Office Action Summary	Application No. 10/830,207	Applicant(s) TJAKRA, HORACE	
	Examiner Jessie Fonseca	Art Unit 3637

DETAILED ACTION

Figure 8: Wirkus et al. (US 5,845,443)

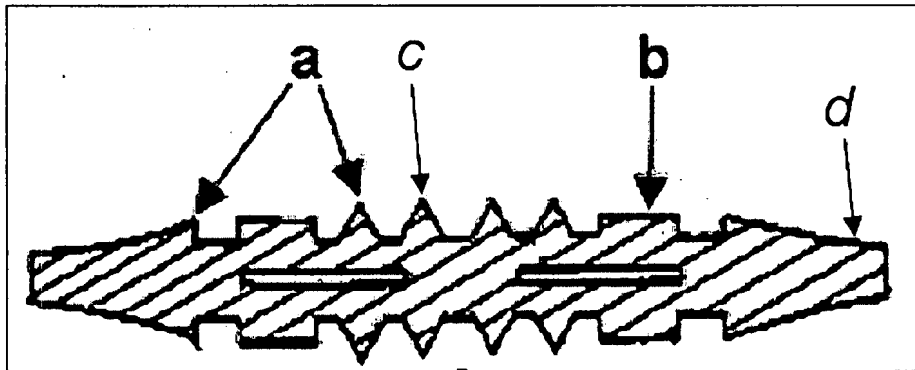
Regarding claim 1: Wirkus discloses a spacer (25) (fig. 8) comprising:

Plurality of projections (a, b) that extend outward from the profile of the spacer (25) (fig. 8 and col. 3, lines 31-34);

Regarding claim 5: Wirkus, in view of Alcazar, further discloses a plurality of projections that are ridges (b) (fig. 8).

Regarding claim 7: Wirkus, in view of Alcazar, further discloses a plurality of projections that are ridges (b) and pointed projections (a) (fig. 8).

Regarding claim 9: Wirkus, in view of Alcazar, further discloses an elongated spacer comprising a plurality of projections (a, b) shaped as ridges (b) or pointed (a) projections that extend outward from the profile of the spacer (fig. 8 and col. 3, lines 31-34). Wirkus, in view of Alcazar, further discloses the sections having varying walls thicknesses from one another, where one of the sections has a portion (c) that is thicker than the portion (d) of the other section (fig. 8).
